TECHNICAL BULLETIN

Document:	TB_T318_027_RIS_tether		Rev: 01
Date:	06/03/2020		
Subject:	RIS tether		
Reference:	Table	Item	Code
Accomplishment:	2020 racing season

Figure 1

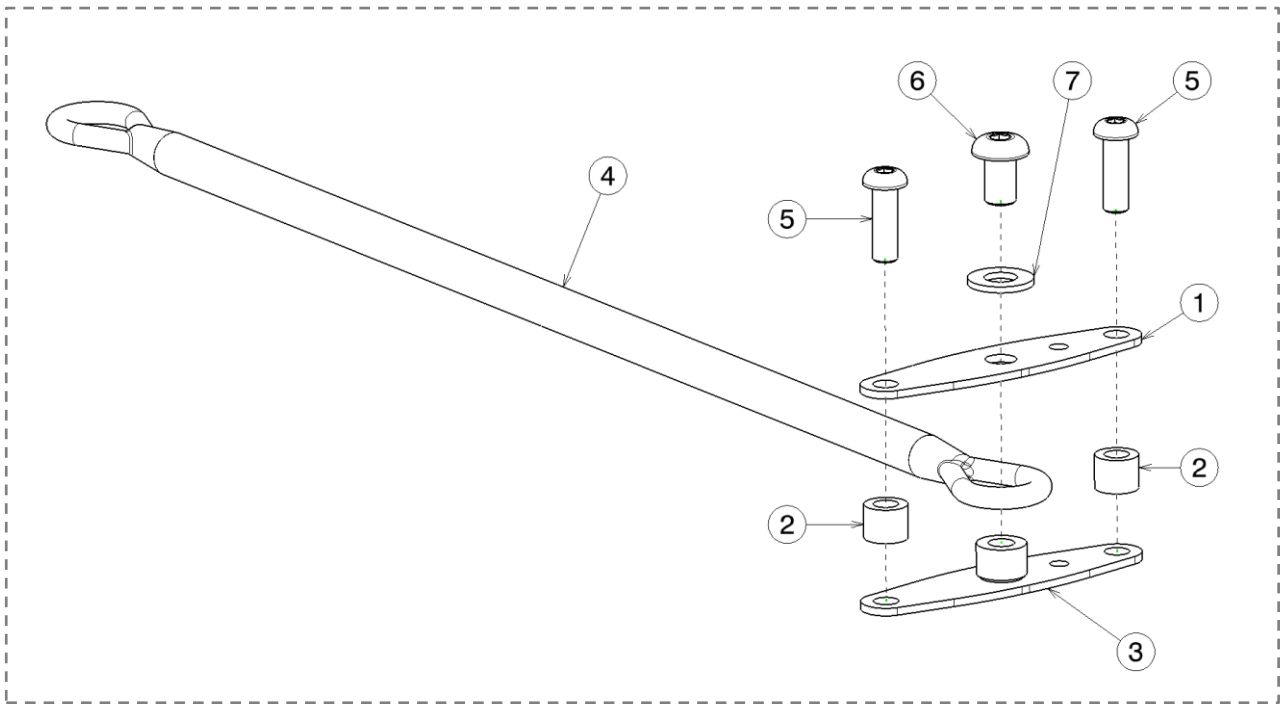
According to FIA safety prescriptions, Tatuus developed a solution in order to fit a tether cable for the Rear Impact Structure.

Please find in Figure 1 and in Table 1 the list of the items to be installed on the car.
